Project: UE.WL

Re: OPA 63

Re: Draft Amendment Number 63 to the Official Plan of the Township of West Lincoln,
Comments on Karst Feature Policy

OPA NO. 63
SCHEDULE “N”

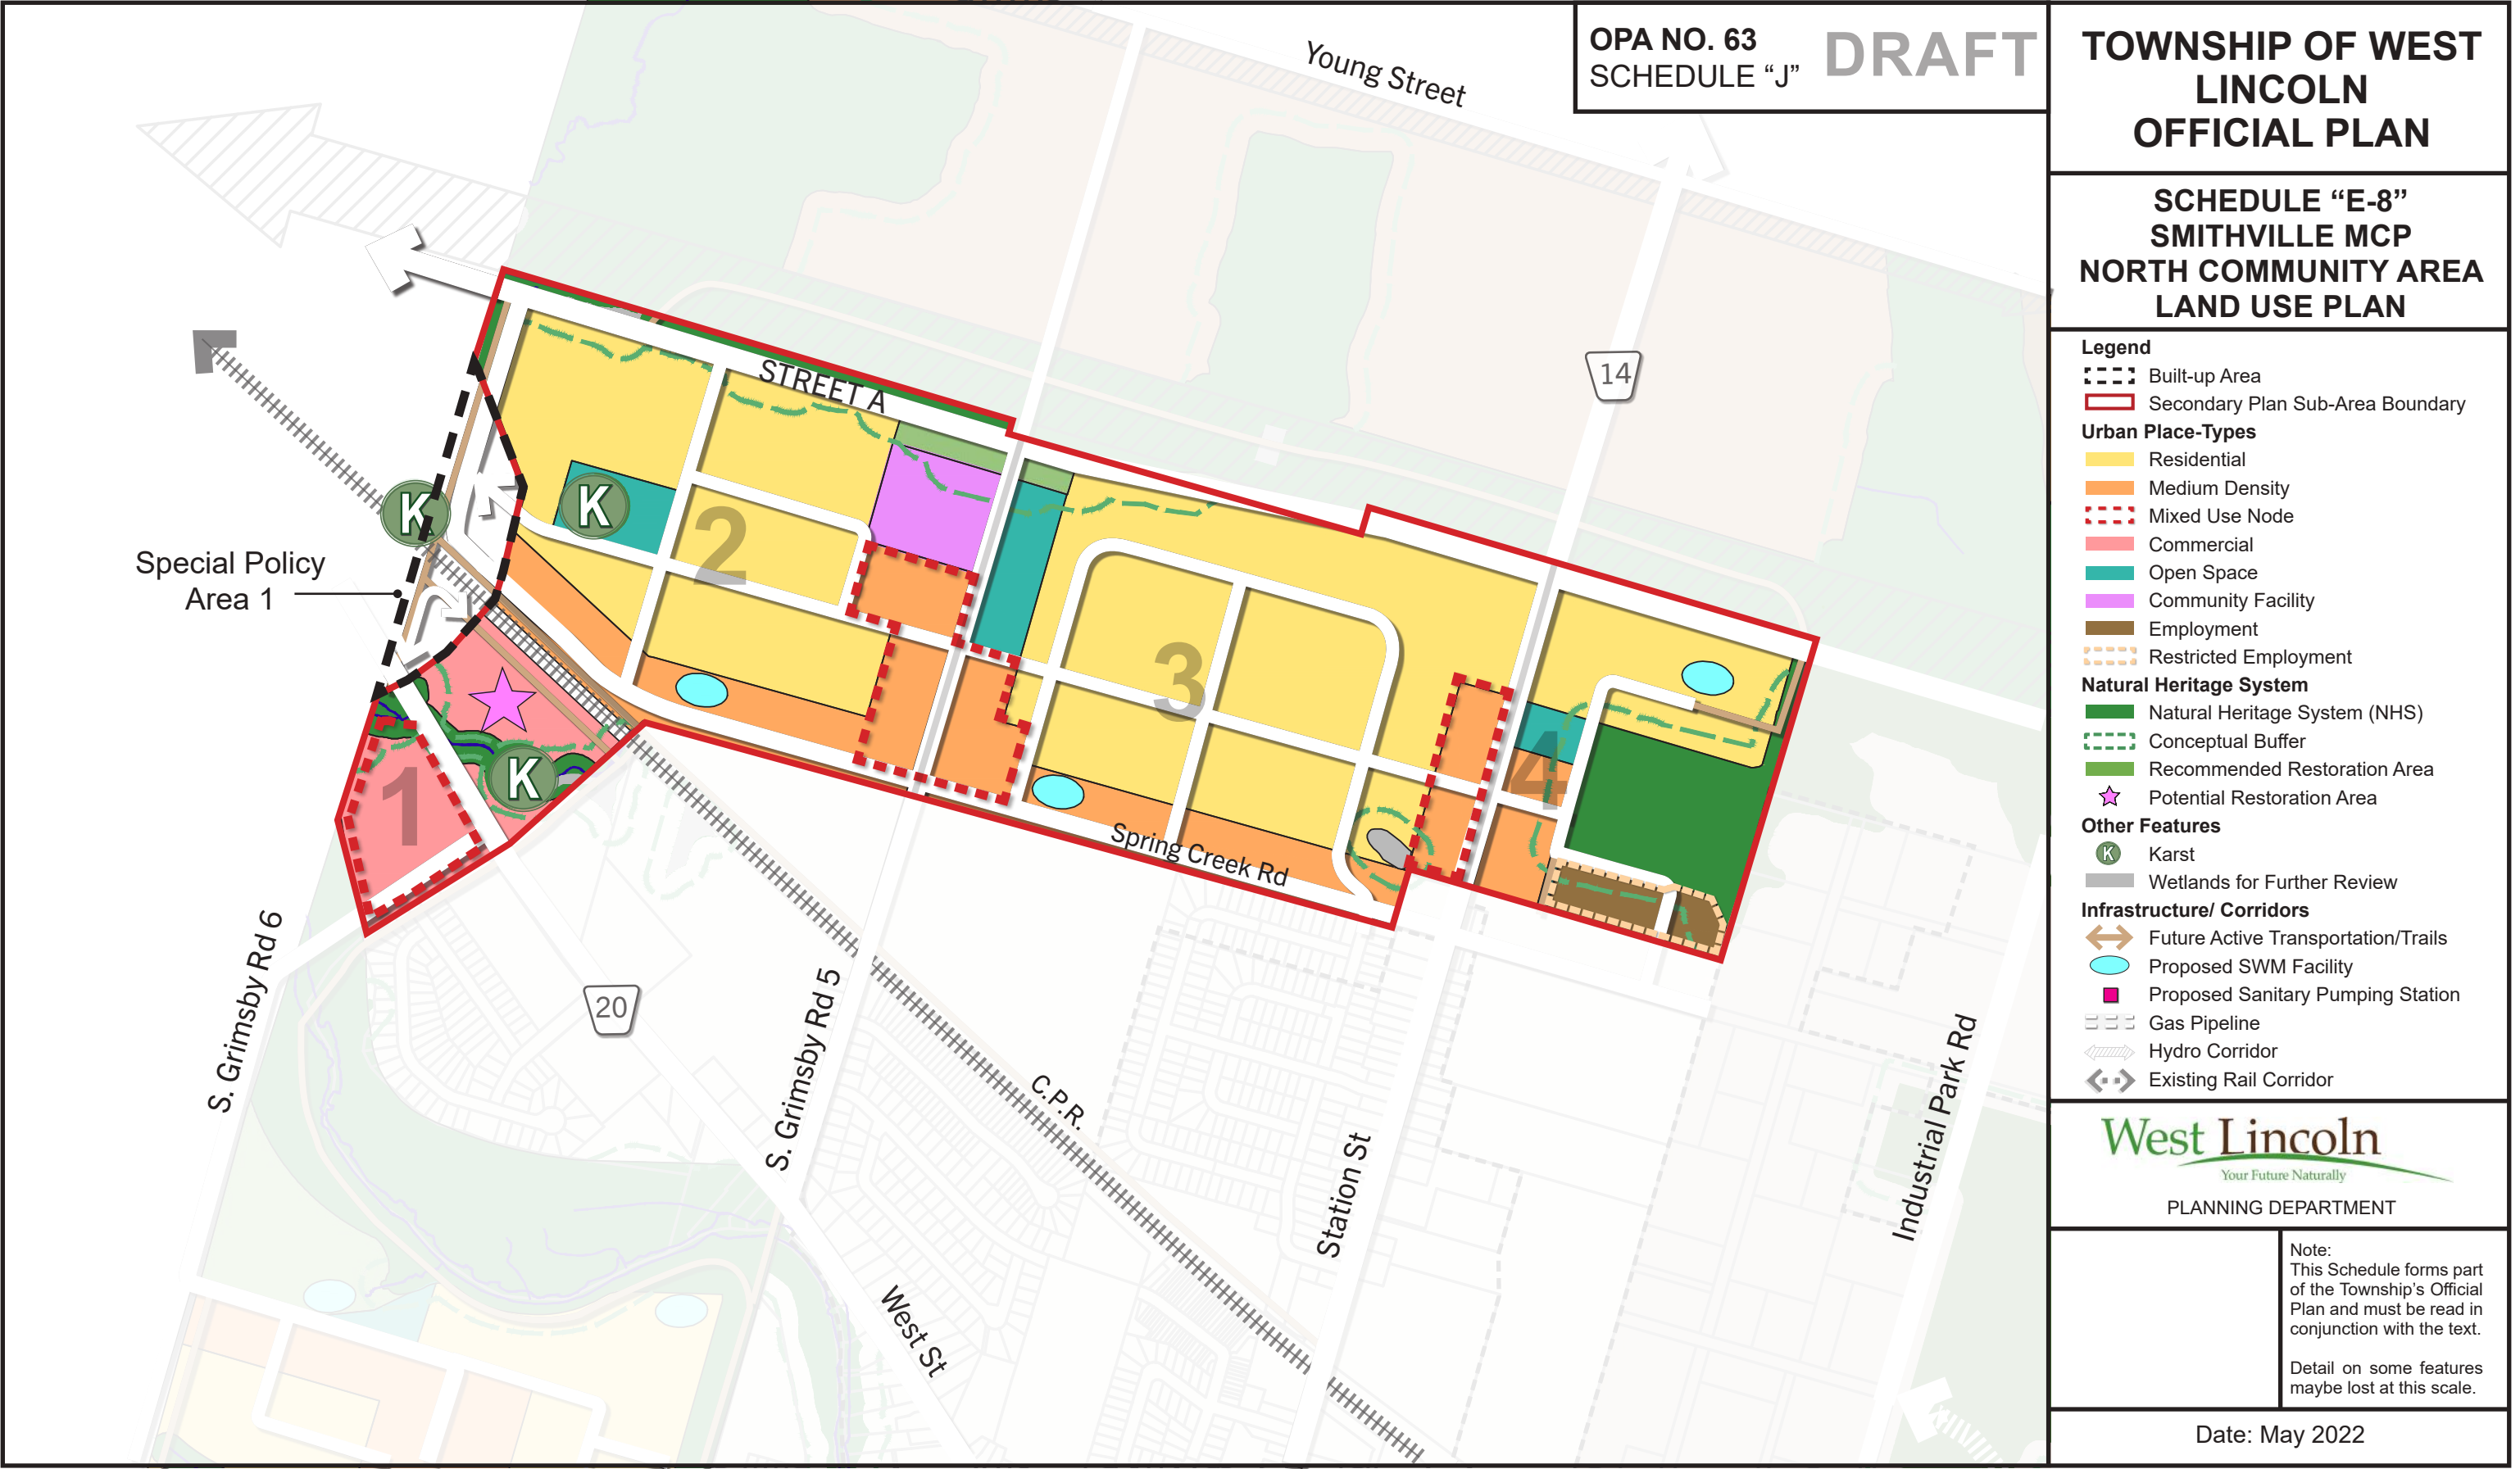
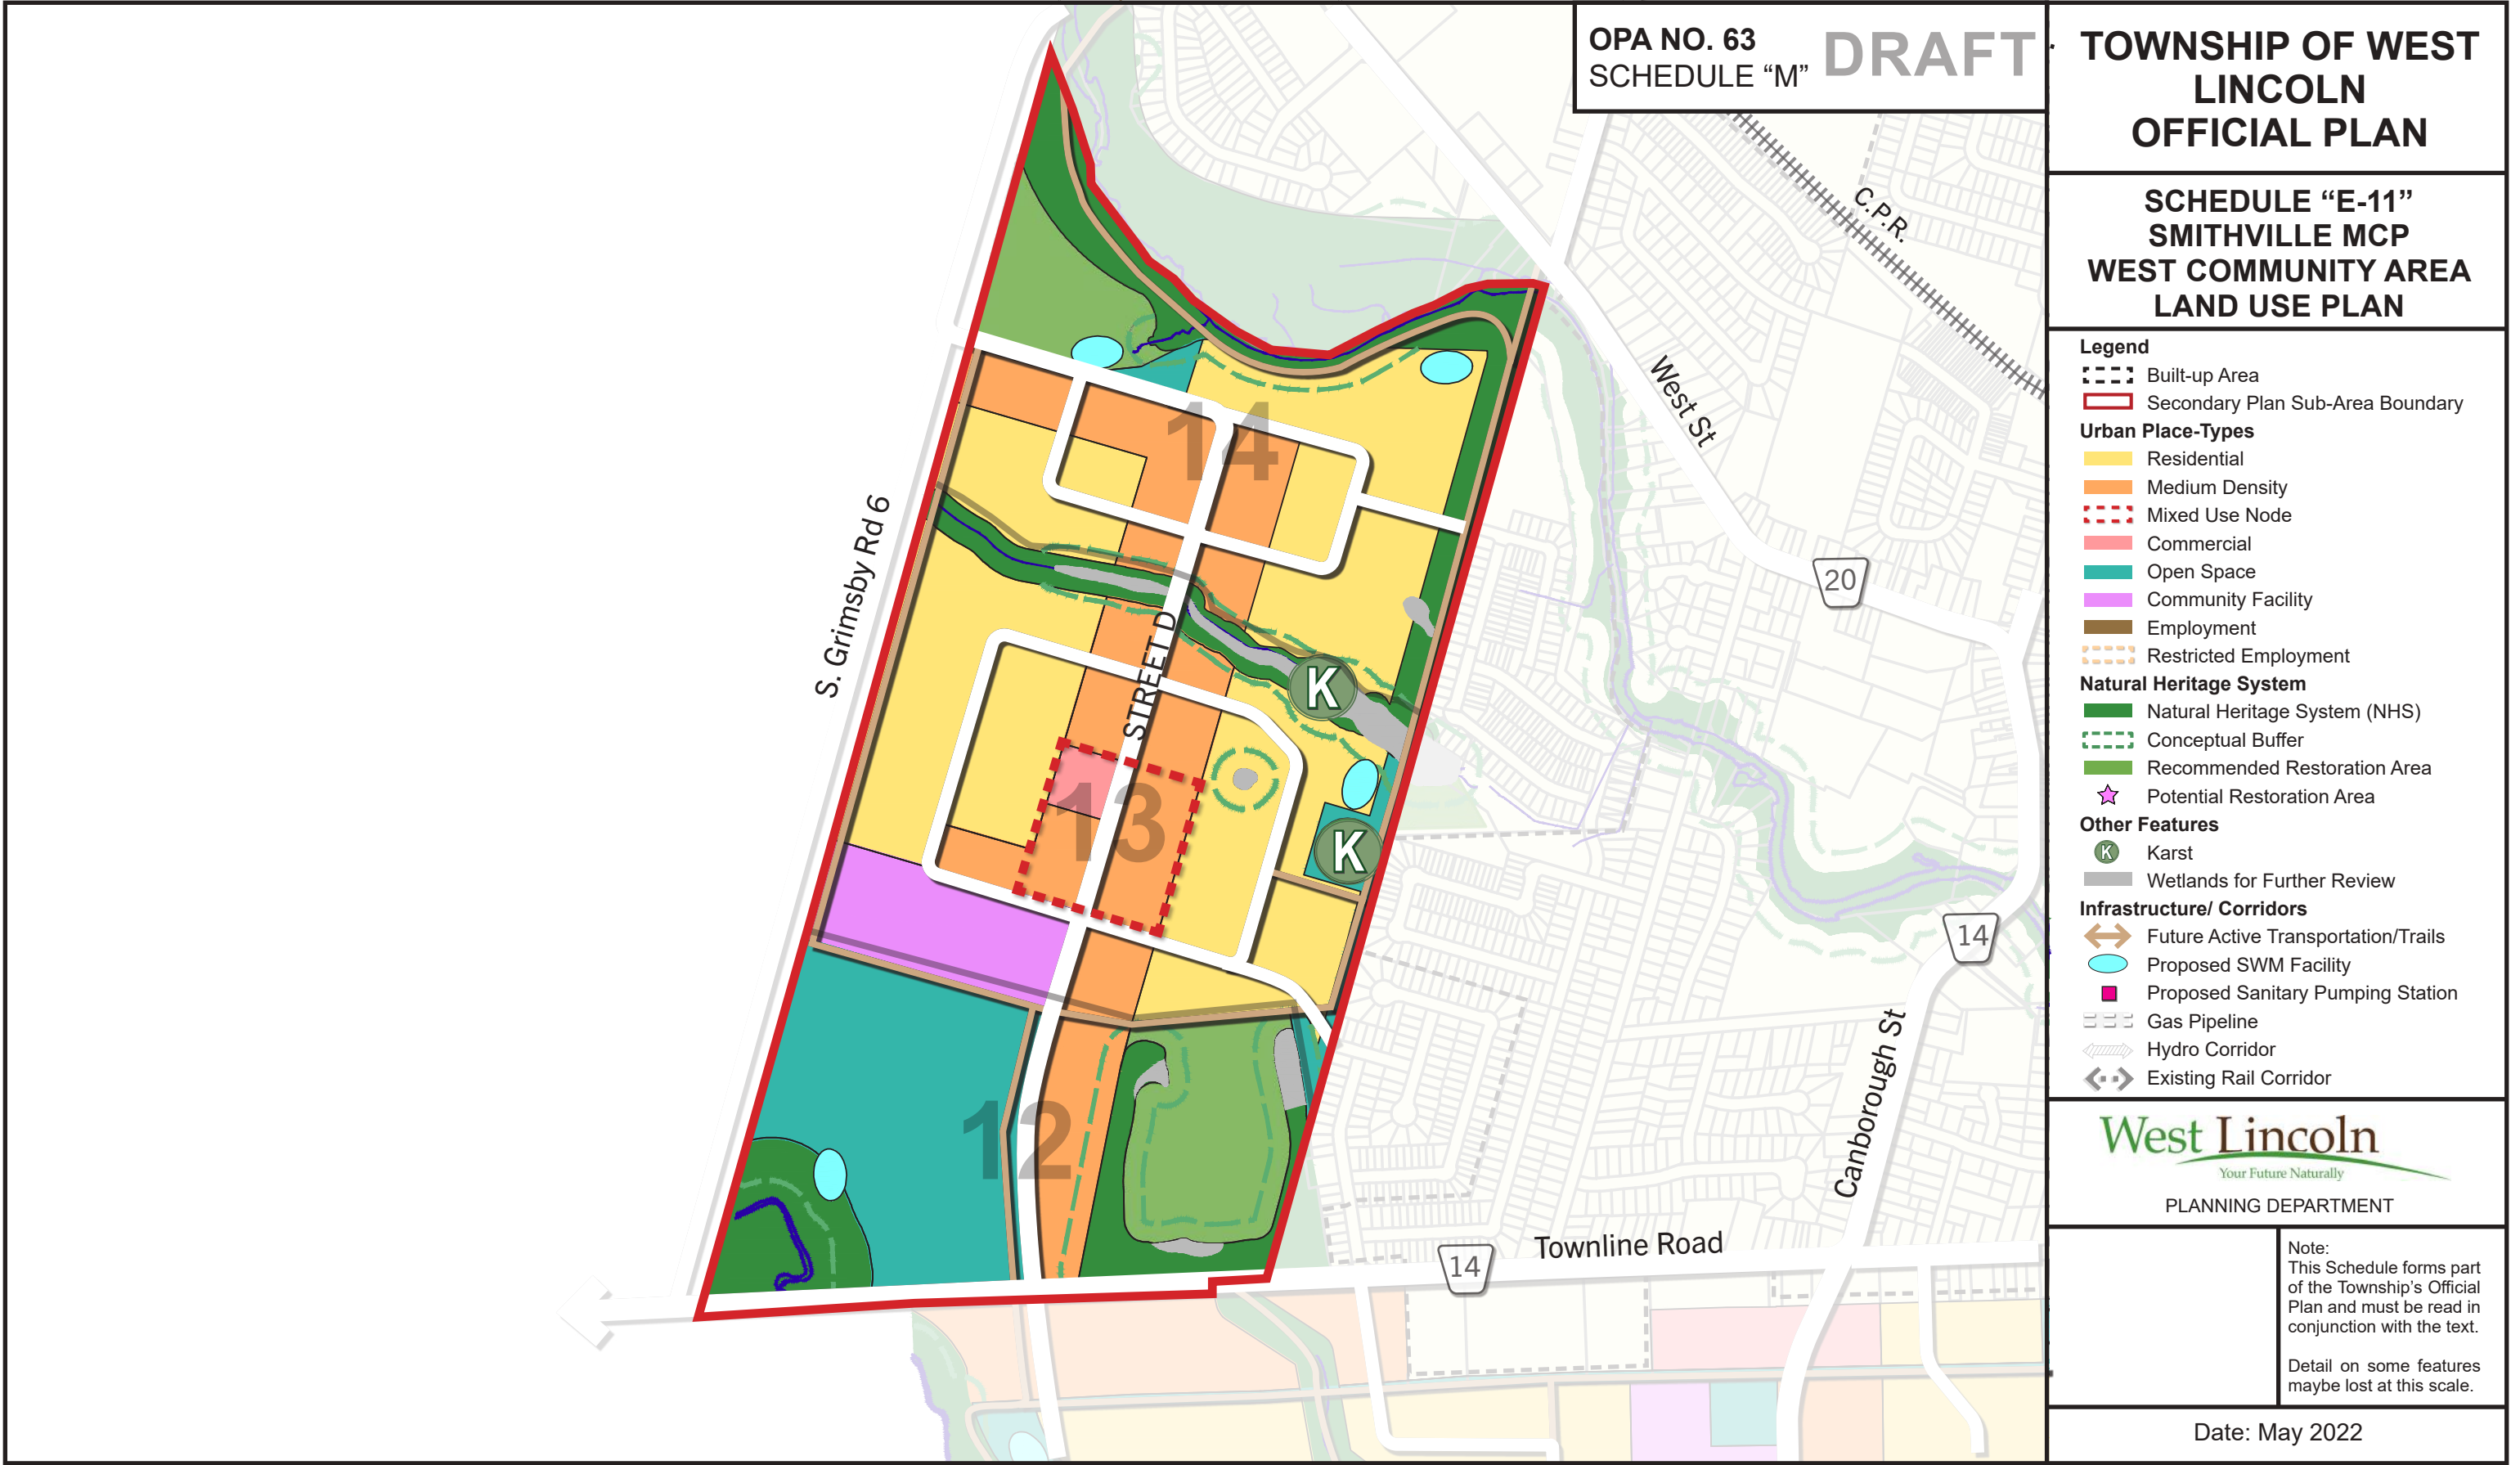
Terra-Dynamics Comment 3. Conflicting Information Pertaining to the Subwatershed Studies Karst Feature SW-1 and the Draft OPA 63 No Development Within 50 m of Karst Feature Shown on Schedule "E-11" (the medium-constraint karst feature shown on Schedule "E-11" to this Plan)

Terra-Dynamics Comment No. 4. Karst Feature Schedule E-8, Northeast "K" (the feature located in the area designated "Open Space" to the north of Spring Creek Road) Does Not Warrant High Karst Constraint Status or Development Exclusion Status Based on Information Presented in the Subwatershed Study Phase 1 and 2 Reports

Figure 1: Township Preferred Concept – February 2022

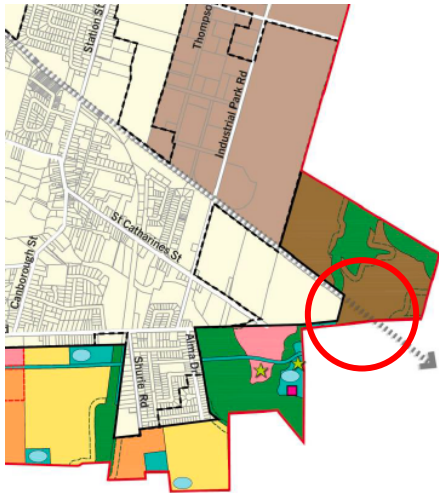
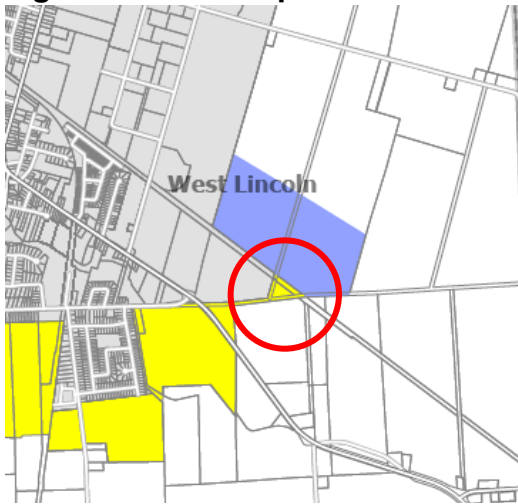
The Preferred Concept Plan continues to show the triangle parcel in the southeast corner as Employment Areas whereas the Region's mapping shows it as Community Area, refer to **Figures 1 and 2**.
